# STAFF REPORT KETCHUM PLANNING AND ZONING COMMISSION MEETING OF DECEMBER 15, 2020

**PROJECT:** Leadville Residences

FILE NUMBER: P20-077

APPLICATION TYPE: Pre-Application Design Review

1 NE Perspective 12" = 1'-0"

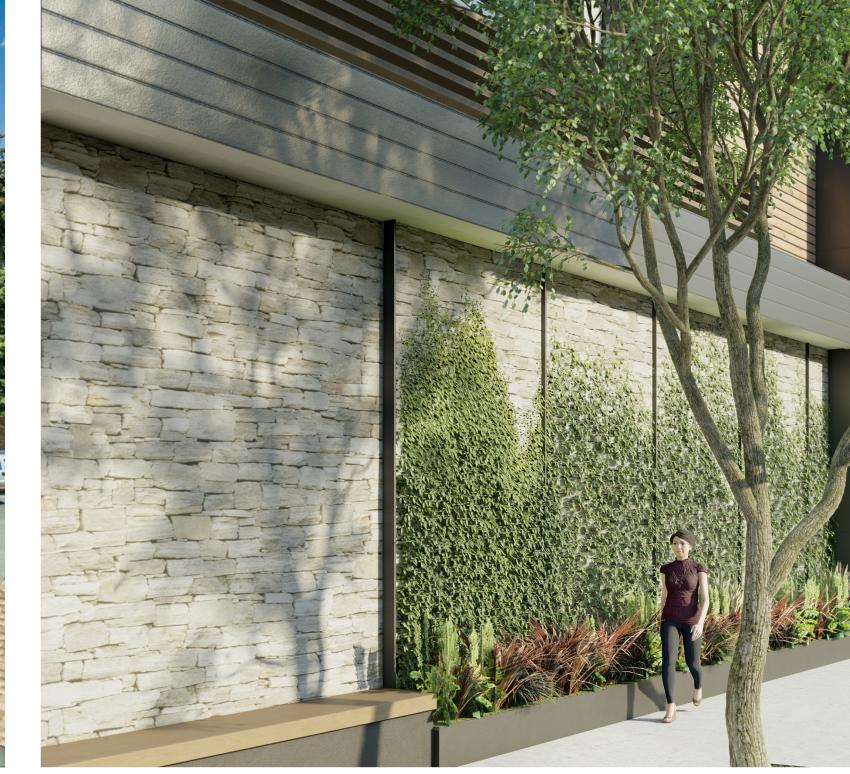
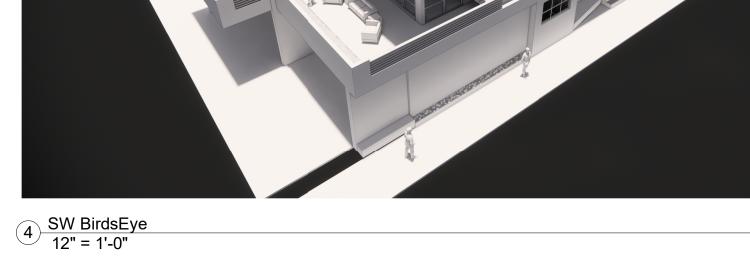
This project ignores local context. Over-scaled, the three-story duplex is considerably larger than neighboring buildings. Massing models (Sheet-003) underscore the duplex's size—the building dominates the streetscape. The project lacks key features, like active storefronts and detailed building facades, that create inviting, sociable, interactive, and dynamic places.

sections

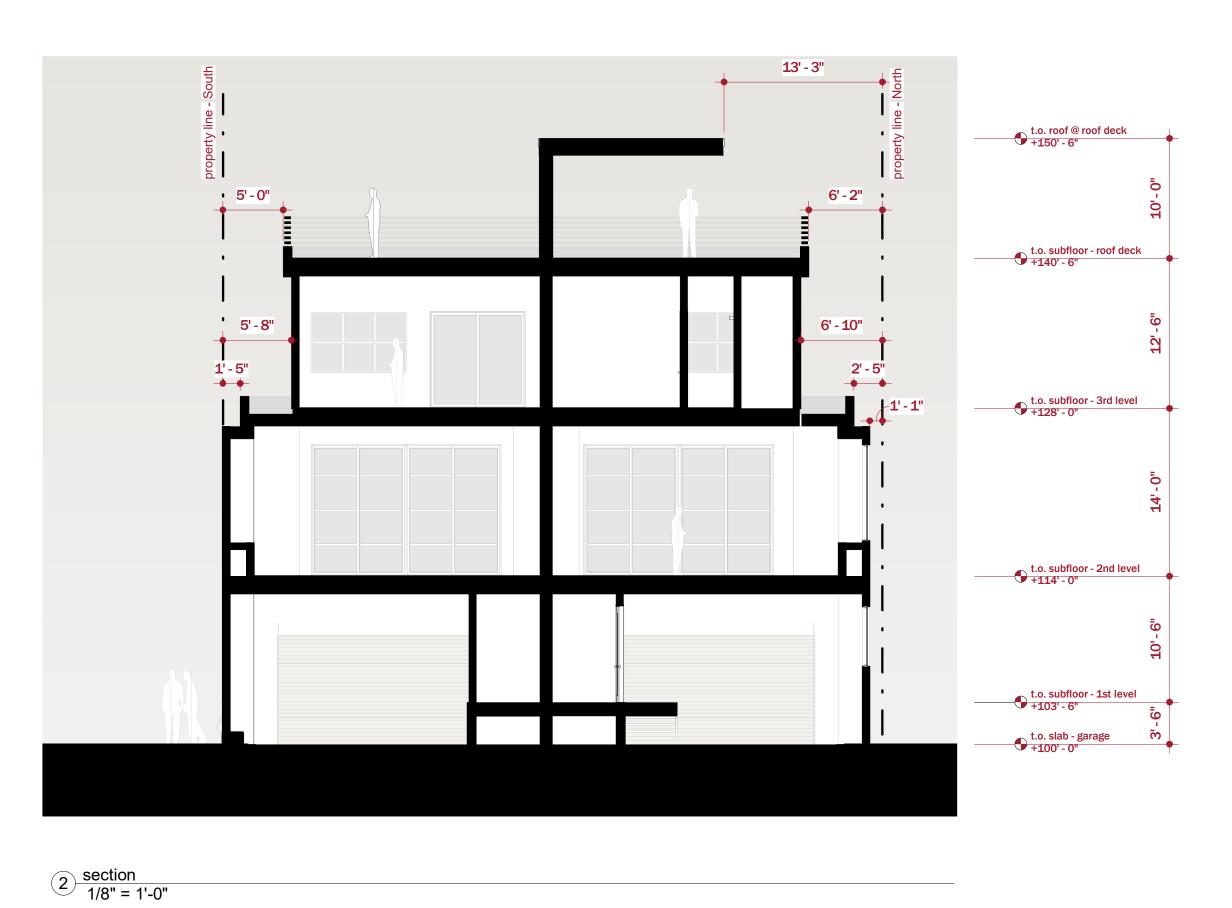
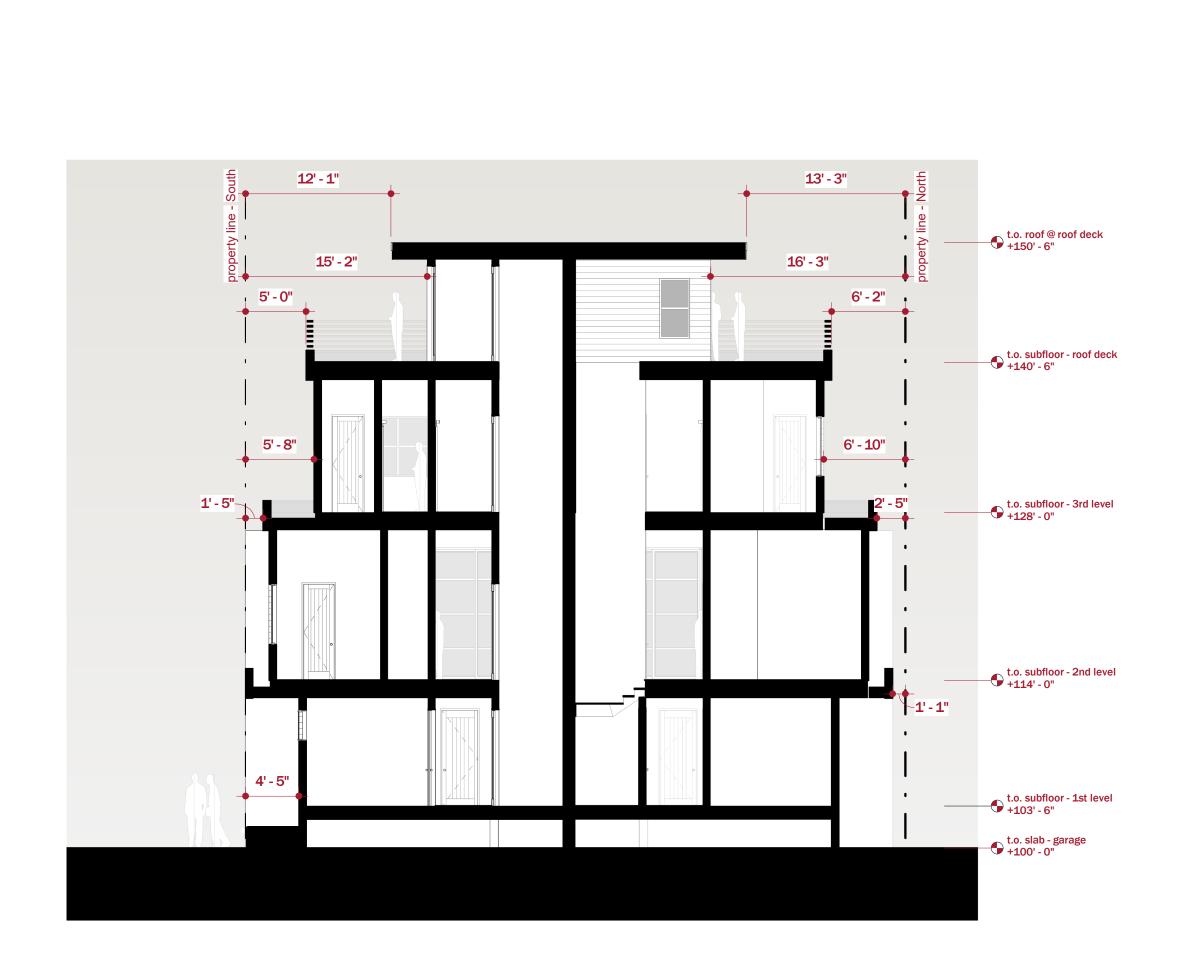
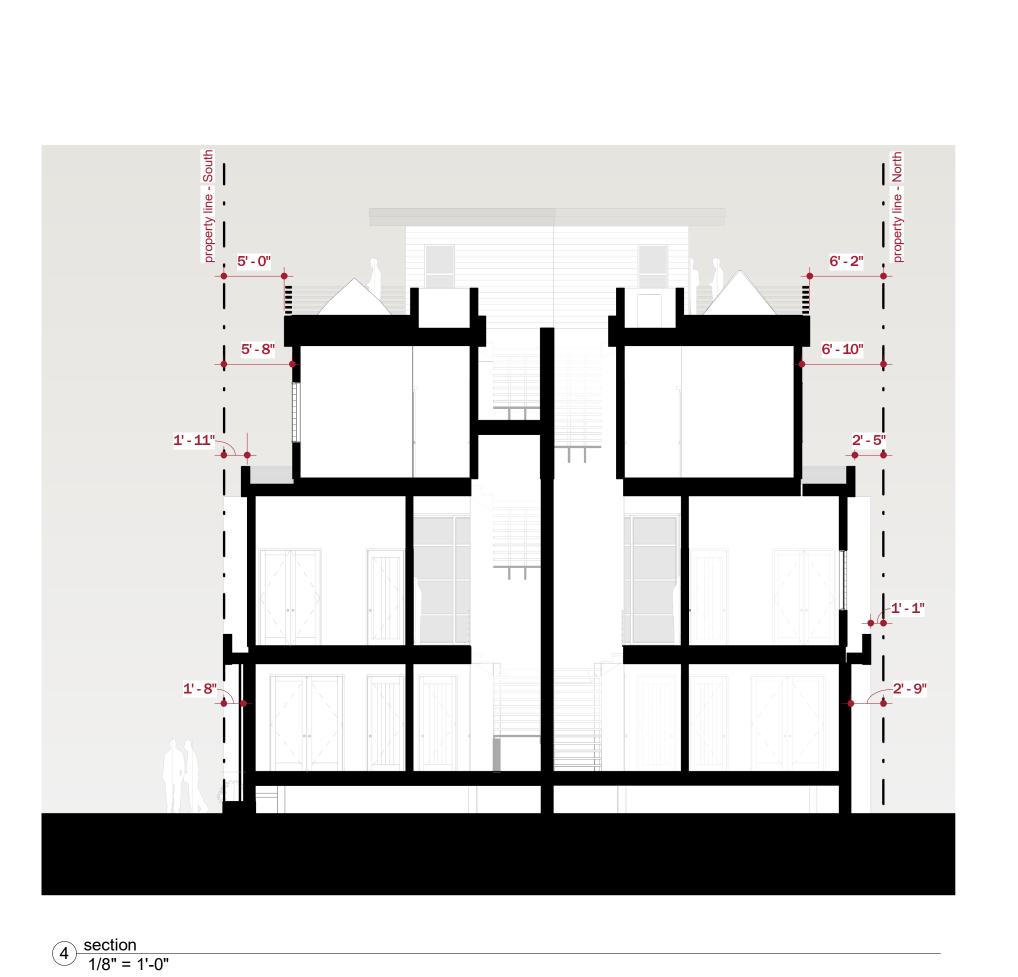
- Stone wall revised
  - o Added stone to east end
  - o 9'-0" added stone to west end
- 4'-6" x 12'-4" recess added
- Metal paneled bump-out revised
  - o Lowered to ground level, top of paneling to be 26'-6" from sidewalk
  - o Original design had bump-out starting at 2<sup>nd</sup> floor extending to level of roof deck
